# Carlyle/Eisenhower East Design Review Board (DRB) Application

PROJECT NAME: Carlyle Block P BLOCK: P

DESCRIBE THE REQUEST BRIEFLY: Approval of minor modifications to the previously approved design of the North Tower of Carlyle Block P.

MEDICAL OFFICE BUILDING AND PODIUM  
DESIGN REVIEW BOARD SUBMISSION  
DECEMBER 07, 2021

# PROPOSED MODIFICATIONS

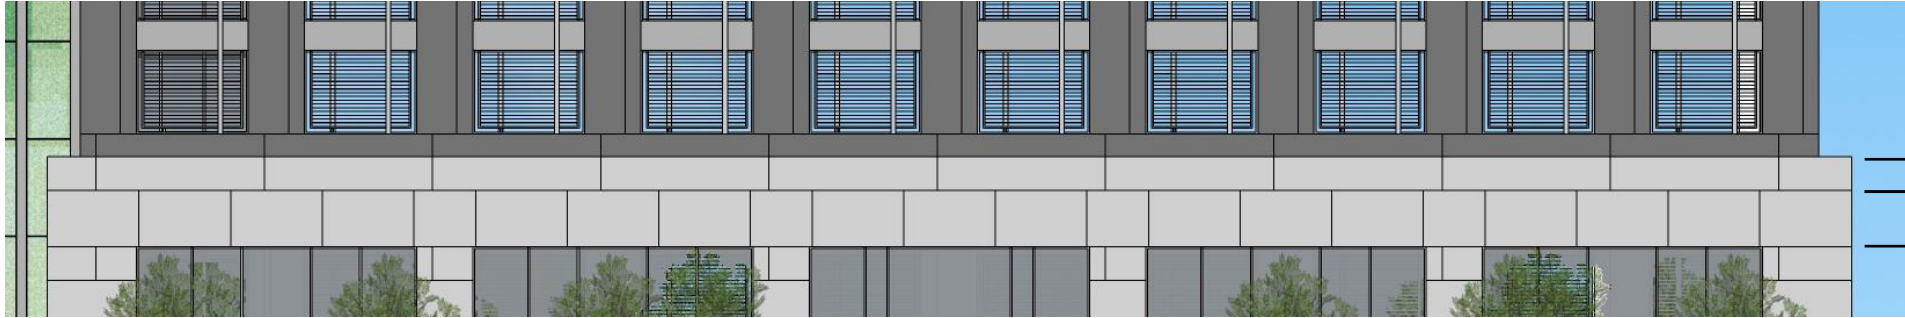
- REVISED PH SCREEN WALL
- MOB REDUCED FROM 7 FLOORS TO 5 FLOORS
- INCREASED FLOOR HEIGHTS AT THE P5 LEVEL AND 6<sup>TH</sup> FLOOR
- METAL PANEL SPANDRELS AND VERTICAL MULLIONS ADDED TO "ZIPPER"
- REVISED PRECAST COURSING AT ARCADE ALONG JOHN CARLYLE
- PRECAST CONCRETE FRAMING TO DIFFERENTIATE POTENTIAL RETAIL BAYS

REVISED  
PENTHOUSE  
SCREEN WALL

REVISED  
PRECAST  
COURSING

ENLARGED ELEVATIONS – ARCADE

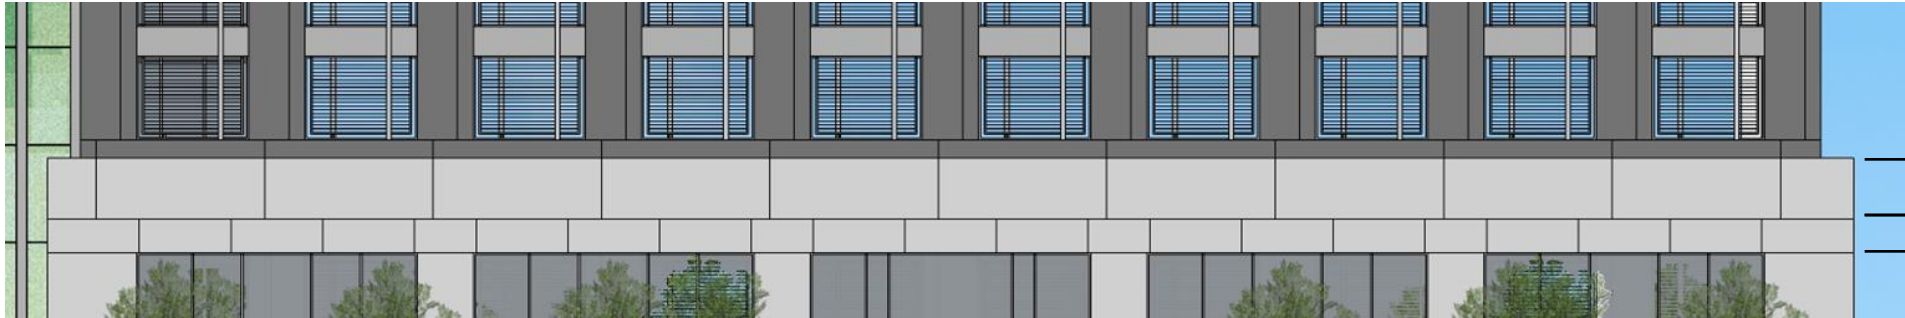
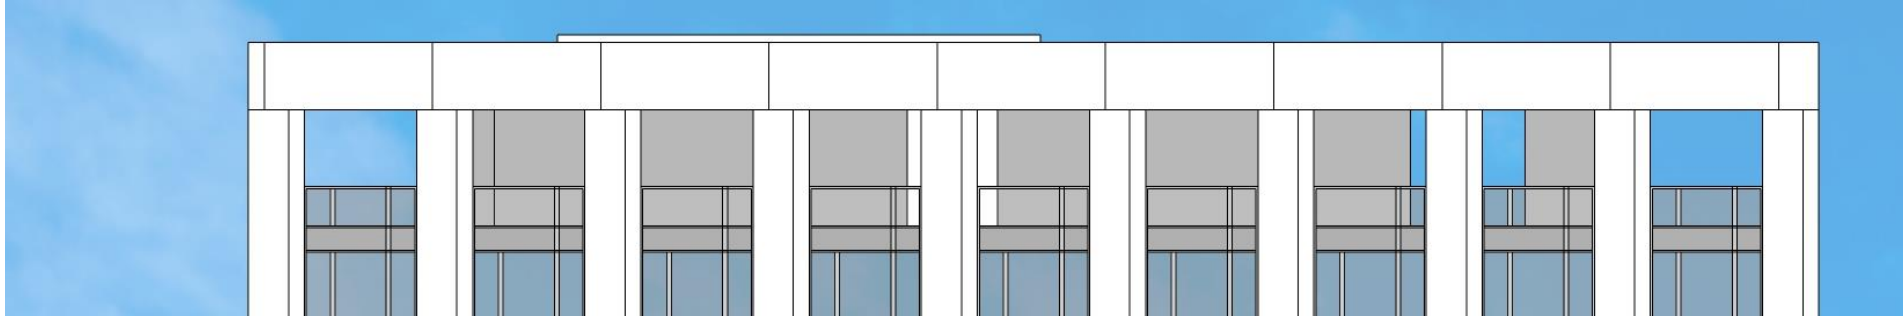
PREVIOUS  
PRECAST COURSING – EAST FAÇADE ARCADE

PRECAST CONCRETE  
COURSING REVISED TO MATCH  
CONDITIONS AT TYPICAL  
WINDOW HEADS AND TOP OF  
PENTHOUSE SCREEN WALL

ENLARGED ELEVATIONS – PENTHOUSE SCREEN WALL

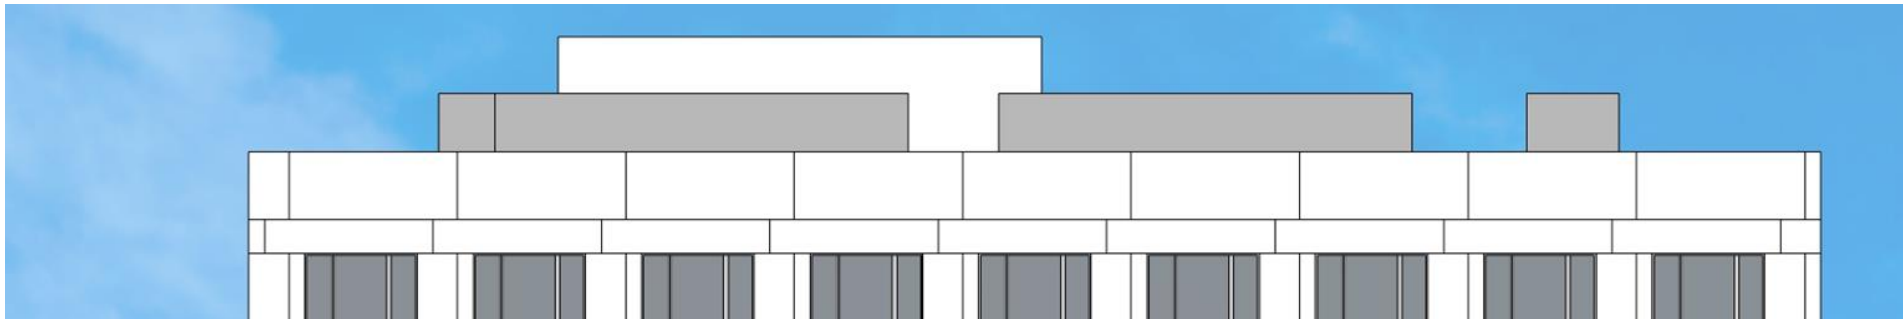
THE PREVIOUS SCREEN WALL EXTENDED ABOVE THE MAIN ROOF SLAB BY 17'-0" WITH OPENINGS THAT PROVIDED VIEWS OF THE MECHANICAL ROOF TOP UNITS BEYOND

THE PROPOSED PENTHOUSE SCREEN WALL HAS BEEN LOWERED TO 8'-0" ABOVE THE ROOF SLAB AND THE OPENINGS REMOVED TO SHIELD THE VIEW OF THE MECHANICAL EQUIPMENT FROM A DISTANCE

ENLARGED ELEVATIONS – NORTH FAÇADE RETAIL

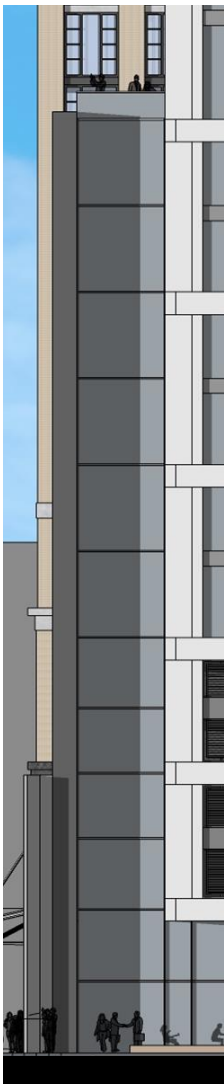
THE PREVIOUS RETAIL  
STOREFRONT CONSISTED OF A  
SINGLE PLANE OF GLAZING

THE PROPOSED PRECAST  
CONCRETE FRAME ALLOWS  
FOR BETTER DISTINCTION  
BETWEEN RETAIL BAYS
